PLANNING AND DEVELOPMENT SERVICES STAFF REPORT

For Planning Commission Meeting of September 10, 2013

**SUBJECT: U-Haul Moving & Storage of Ann Arbor Site Plan for City Council Approval
(3655 South State Street)
File No. SP13-007**

**SUBJECT: U-Haul Site Plan for City Council Approval
(3655 South State Street)
File No. SP13-007**

1 CONCEPTUAL ARCHITECTURAL FLOOR PLAN / BLDG. 'G' - LIGHTING LAYOUT

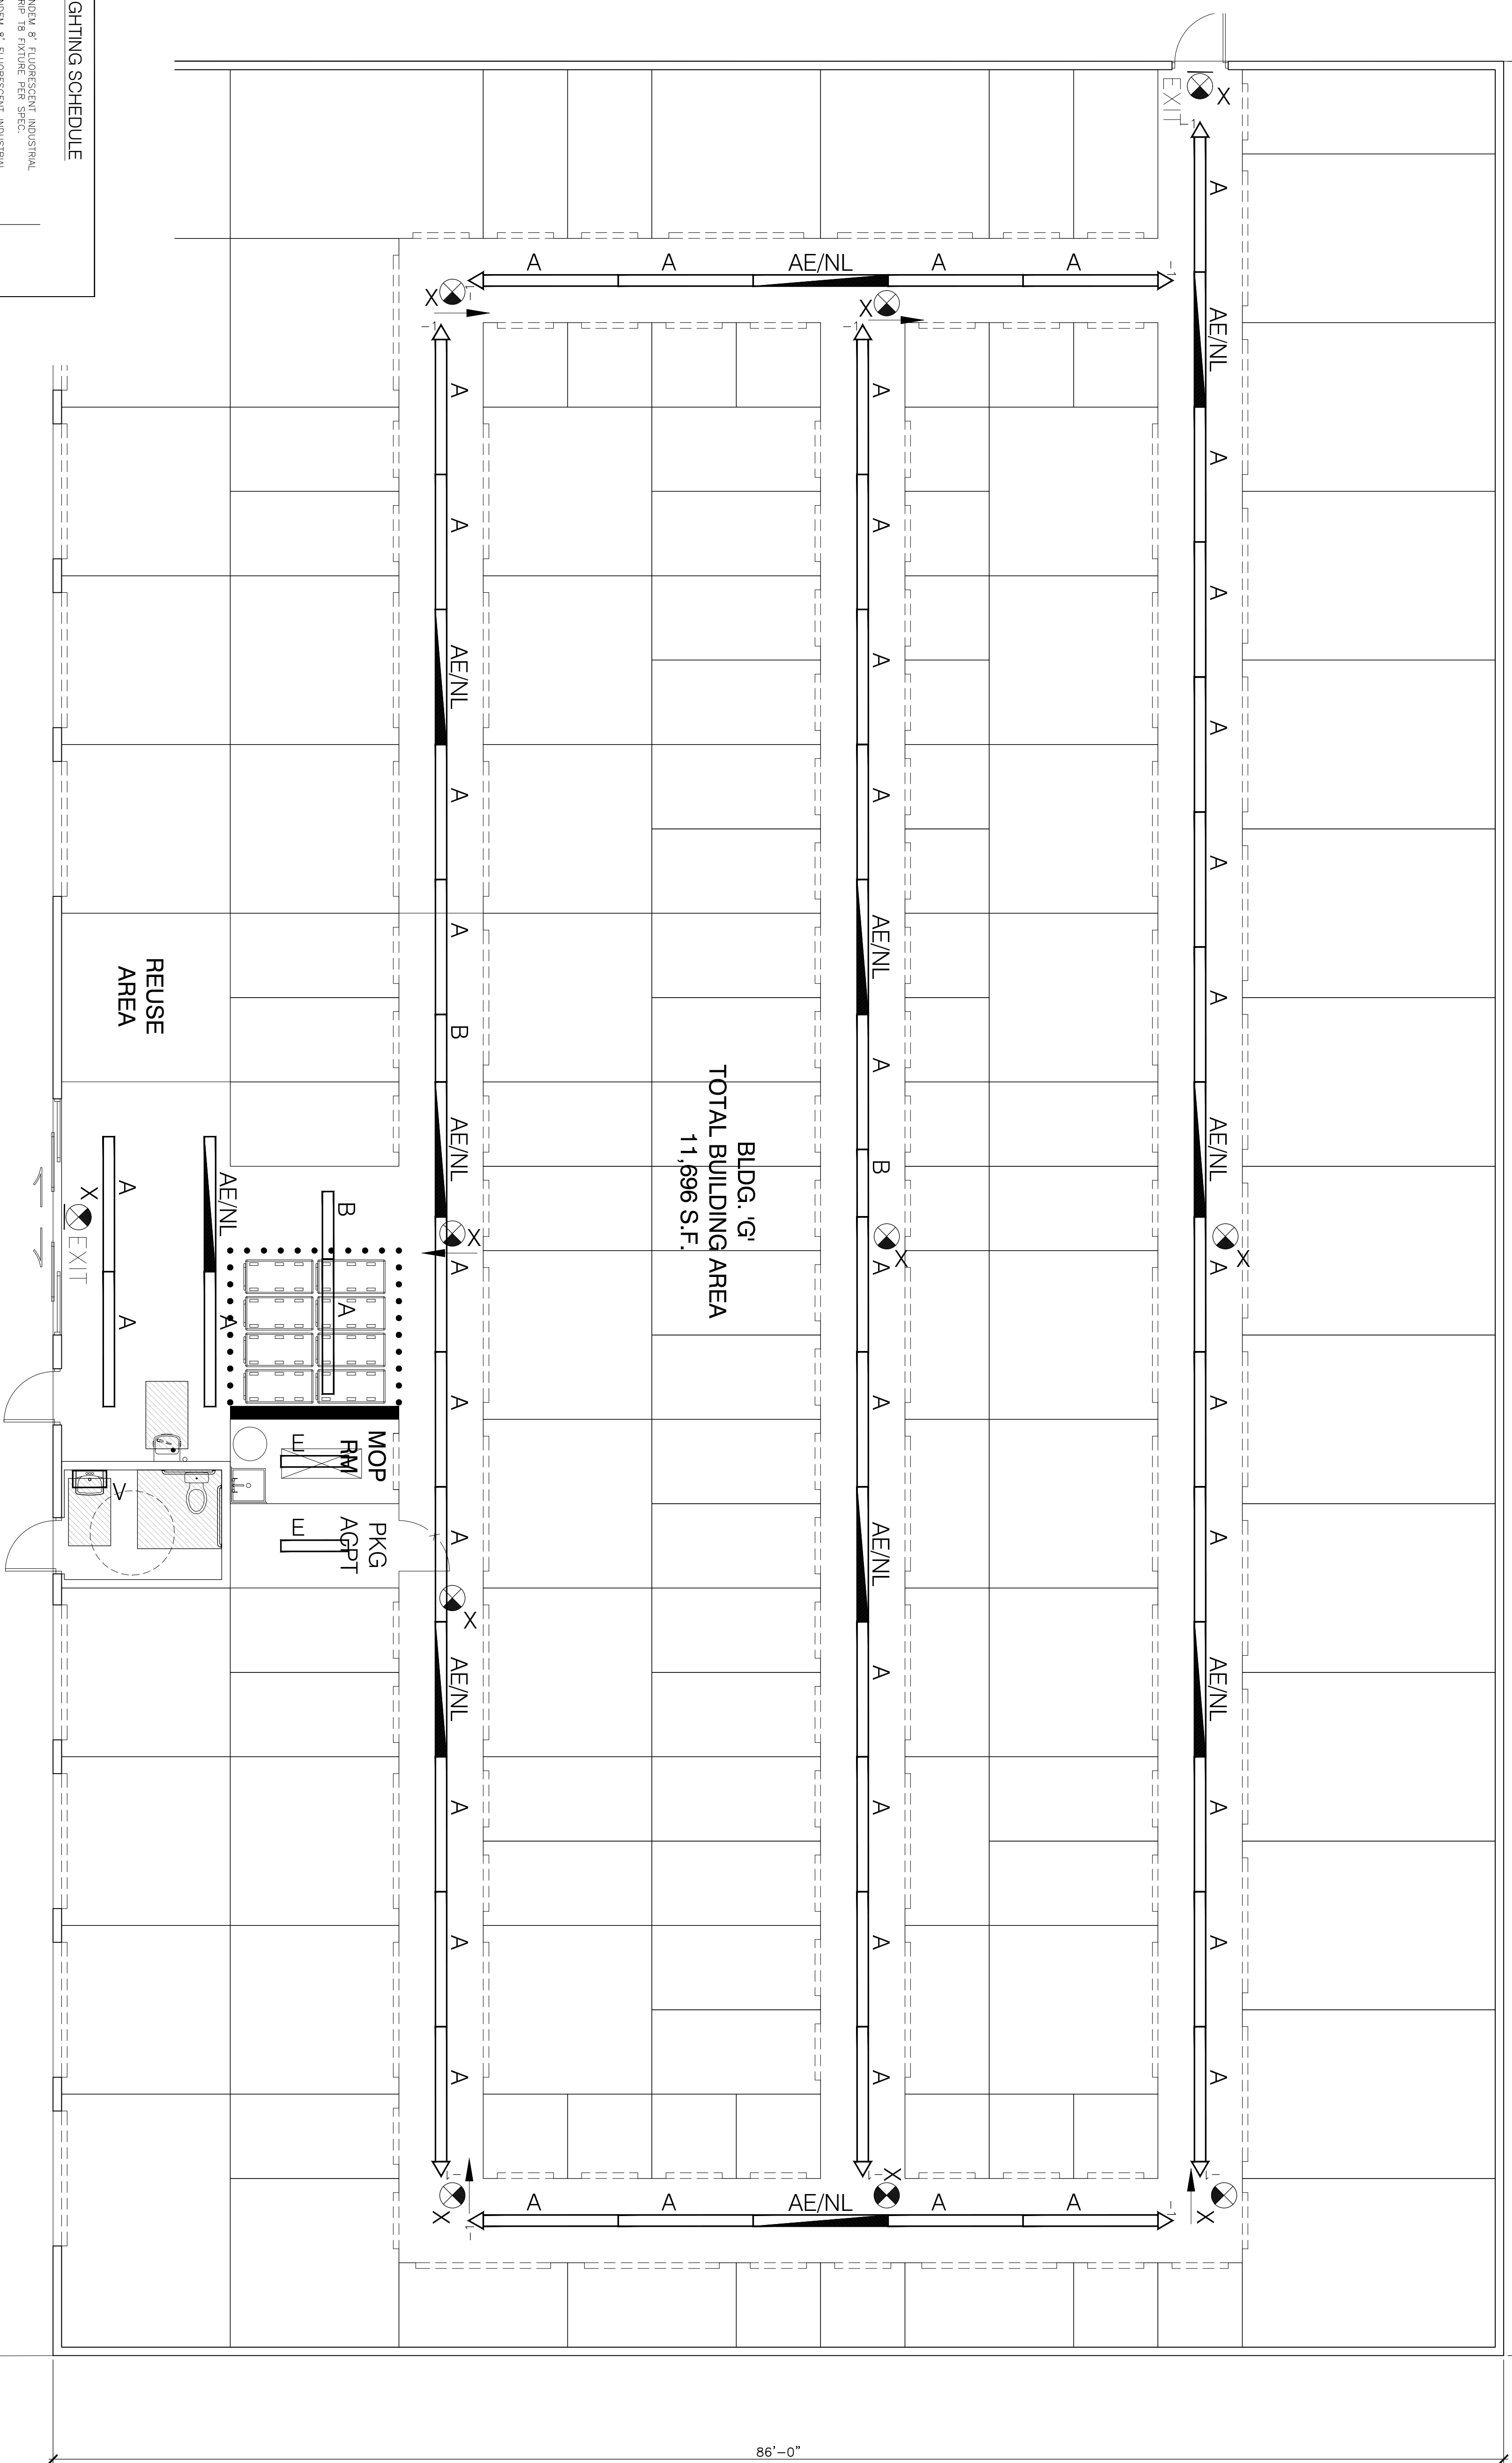
Lighting (Interior and Exterior) – An exterior photometric plan has been attached. At the request of Planning Commission, the petitioner has provided an interior lighting and egress plan for the enclosed self-storage. Interior lighting and egress plans will be reviewed at the building permit stage for adherence to applicable building codes.
